CITY OF ALBUQUERQUE

February 7, 2017

RE: **Lot 2 Block 2 Unit 22 Volcano Cliffs**
8020 Canoncito Dr. NW (S.A.D. 228)
Grading and Drainage Plan
Engineers Stamp Date 2/2/17 (D10D0003C2)

ENGINEER'S SEAL  2/2/17 DAVID SOULE P.E. #14522	LOZOYA RESIDENCE 8020 CANONCITO DR NW GRADING AND DRAINAGE PLAN  <i>Rio Grande Engineering</i> 1606 CENTRAL AVENUE SE SUITE 201 ALBUQUERQUE, NM 87106 (505) 872-0999	DRAWN BY: WCWJ DATE: 2-02-17 21706-LAYOUT-2-01-17 SHEET # JOB # 21706

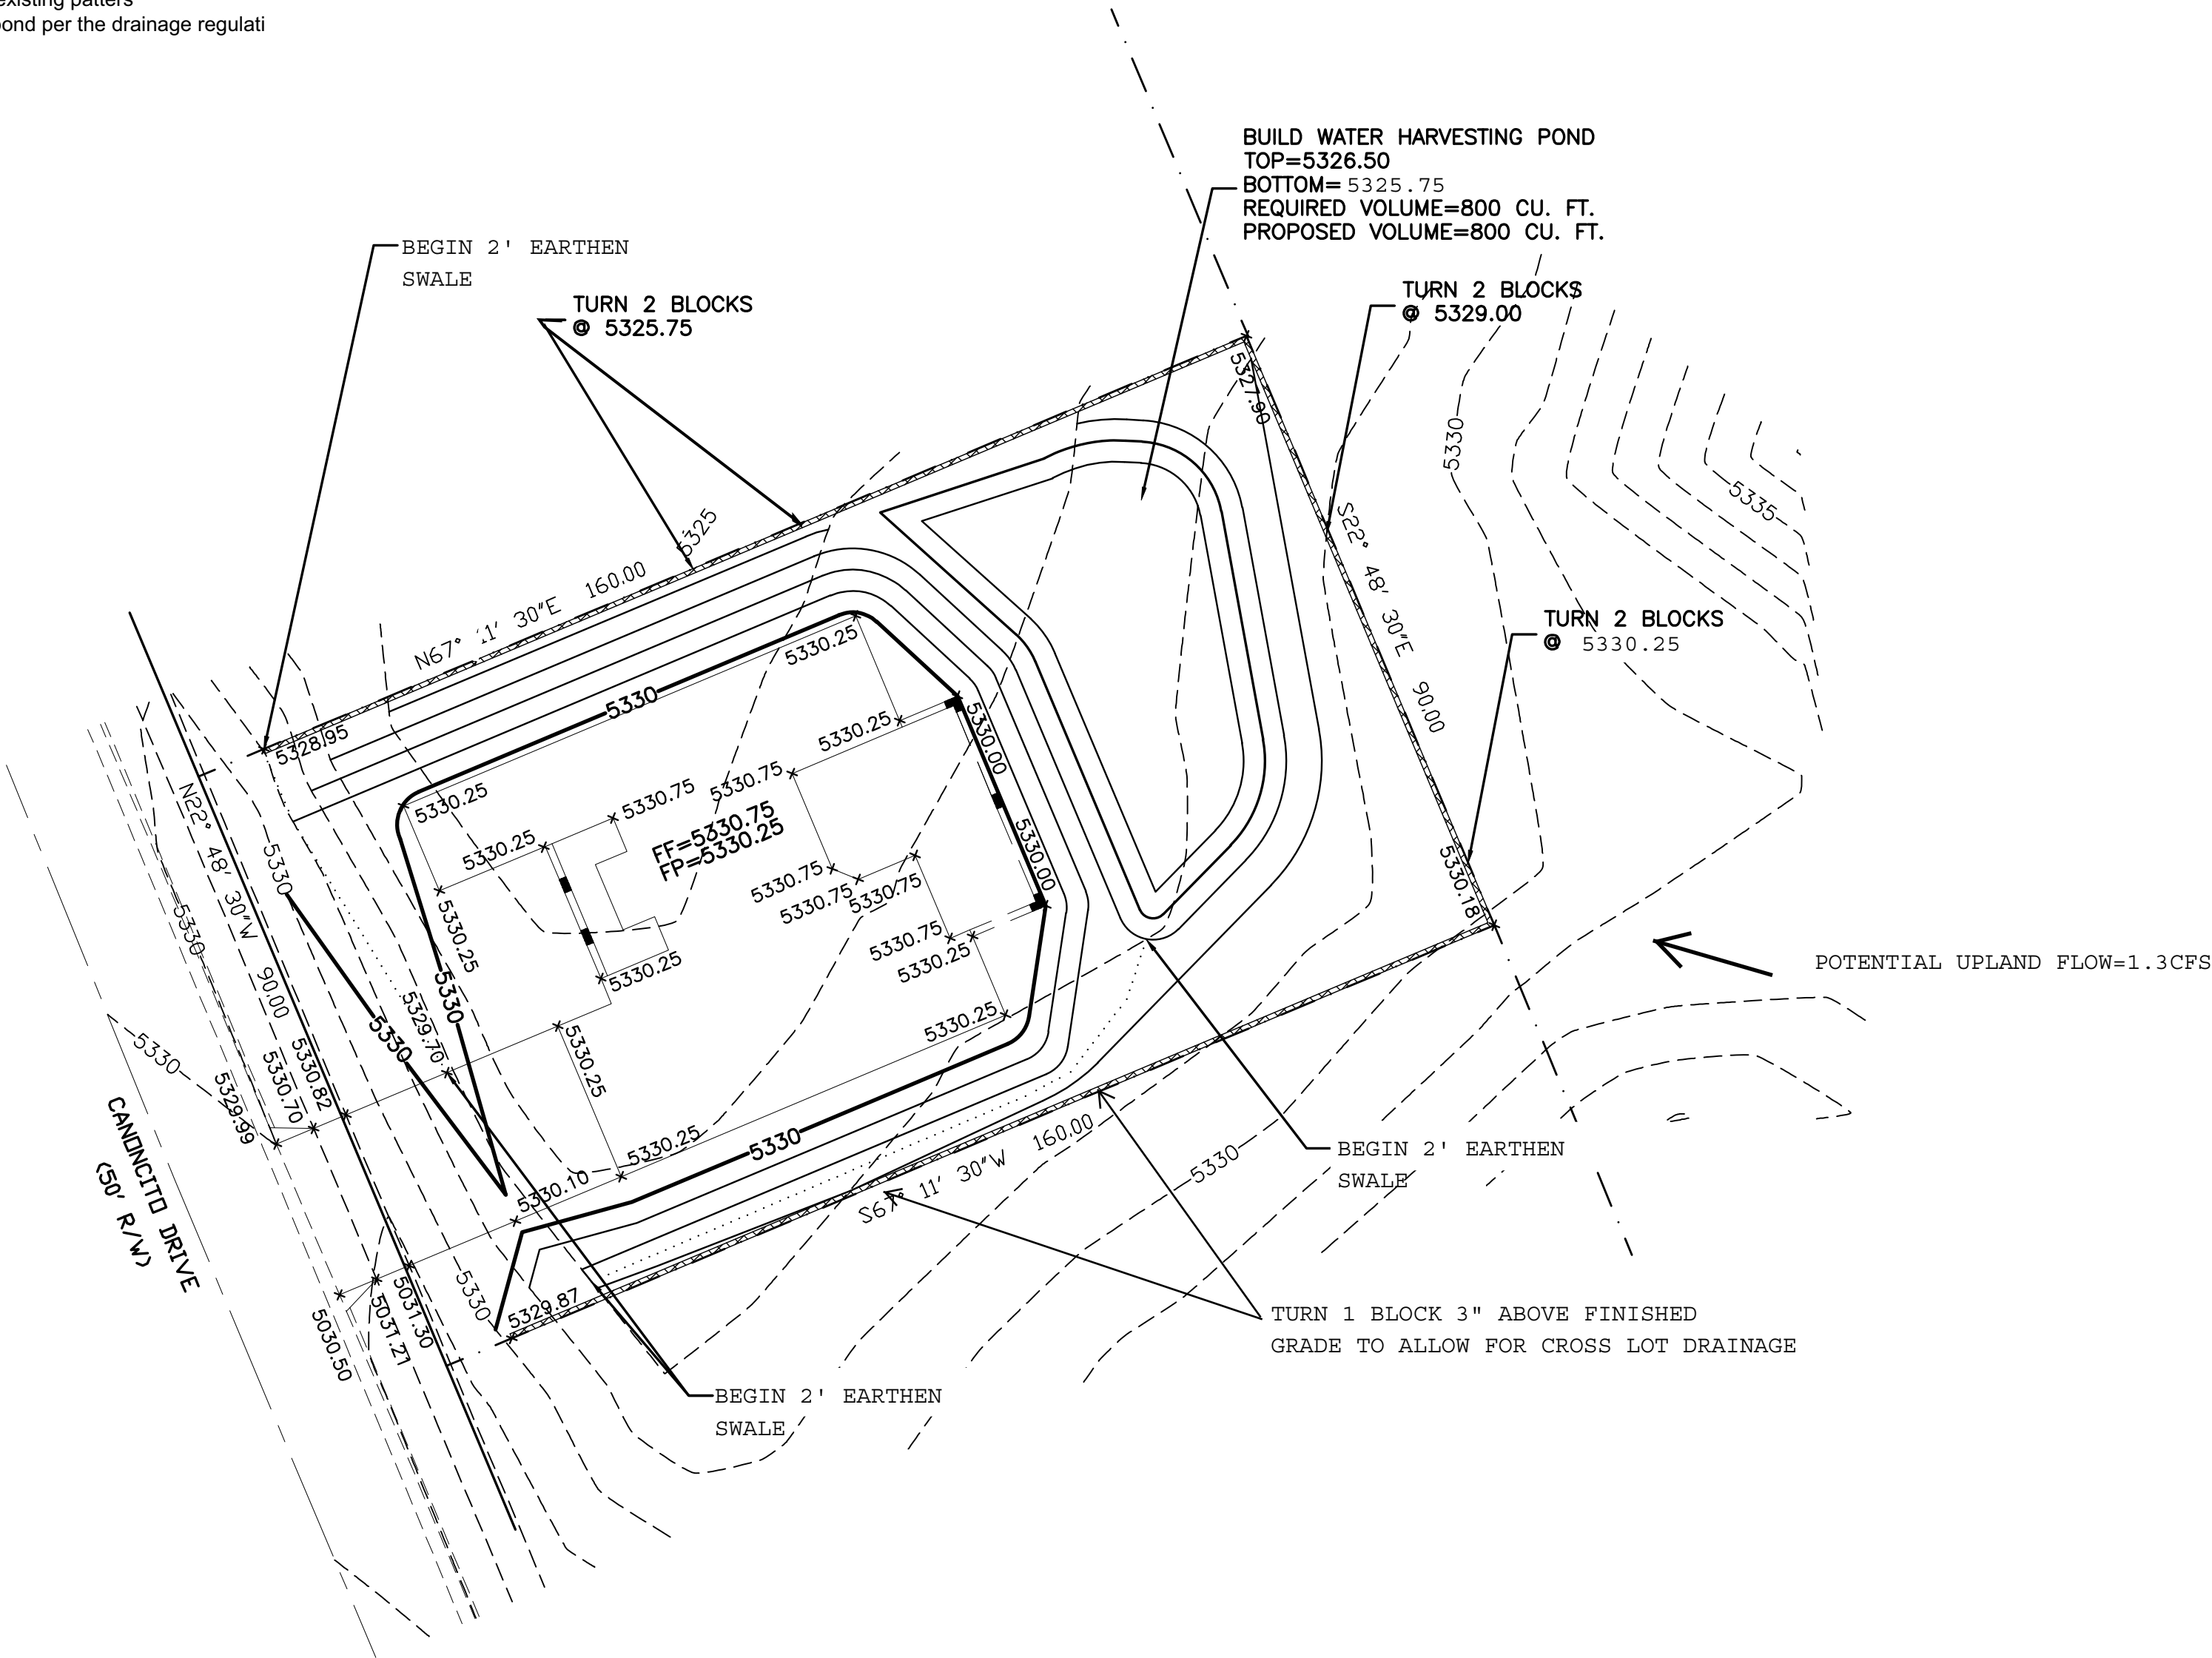
- The turn blocks are located wrong, the turn blocks should be located in the 10' PUE, which will allow flows to pass through the rear yard, accepting flows from the north heading south, eventually entering Kimmick Road.
- Show the 10' PUE in the rear yard. Provide a swale in the PUE, 1 foot away from the block wall.
- Along with the 3" above grade statement, place the height of the block as a spot elevation.
- Provide a statement that a pad certification is required before a Building Permit is released.
- Provide a statement that the block fence requires a separate permit and the approved grading plan must be provided with the plan set and permit.
